Docket Item # 12
BAR CASE # 2006-0278

BAR Meeting
January 17, 2007

ISSUE: Addition and alterations
APPLICANT: Robert Brandt
LOCATION: 219 South Royal Street
ZONE: RM/Residential

Figure 1 – Front elevation

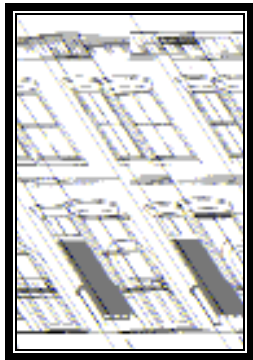
Existing brick house – The applicant proposes to replace the existing multi-light wood windows in the front of the house with new Pella Architects Series, wood, simulated divided light, double hung windows. The new windows will have a two-over-two configuration. The existing front door is a six panel wood door. The drawings do not indicate whether this door will be retained or another six-panel door will be installed. Three existing window openings on the west side of the house (one standard window on the first story, one standard window on the second story, and one circular window lighting the stair hall in between the first and second stories) will be infilled. The drawings do not provide any information about how they will be infilled, but presumably it will be done with brick to match the existing. Two Velux skylights will be installed in the roof of the brick portion of the house. One is shown on the south side of the house above a bathroom. The other is above the new stairhall and spans both the brick portion and the proposed new addition. The drawings call for the existing brickwork to be patched and painted. Currently, the front (east) and south sides are painted but the north side is not.

With respect to windows, Staff notes that the *Design Guidelines* recommend the use of true-divided-light windows and discourage the use of simulated divided light windows except in areas with minimal visibility from the public way (Windows – Page 2). However, Staff believes the use of simulated divided light windows and doors would be appropriate for the addition as it is new construction and the windows are well removed from public view. On the other hand, Staff believes the new windows to be installed in the front façade of the historic brick section should be true-divided-light windows. These windows are immediately adjacent to the sidewalk and highly visible. As explained in docket item #12, Staff believes the two standard, rectangular window openings in the south wall of the brick section should be retained. If retained, these should also have true divided light replacement windows.

As noted above, it is not clear whether the existing six panel front door is to be replaced. If the door is replaced, the new door should be appropriate to the Victorian appearance of the brick front section and should be approved by Staff prior to installation.

1. That the fiber cement siding be smooth and installed so that the nails do not show;
2. That any replacement windows in the brick section be true-divided-light windows;
3. That the front door, if replaced, be appropriate to the Victorian period of the brick portion of the house and be approved by Staff prior to installation;
4. That the skylights have integral shades; and,
5. That the following statement must appear in the General Notes of all site plans and on all site plan sheets that involve demolition or ground disturbance (including sheeting and shoring and grading) so that on-site contractors are aware of the requirement:
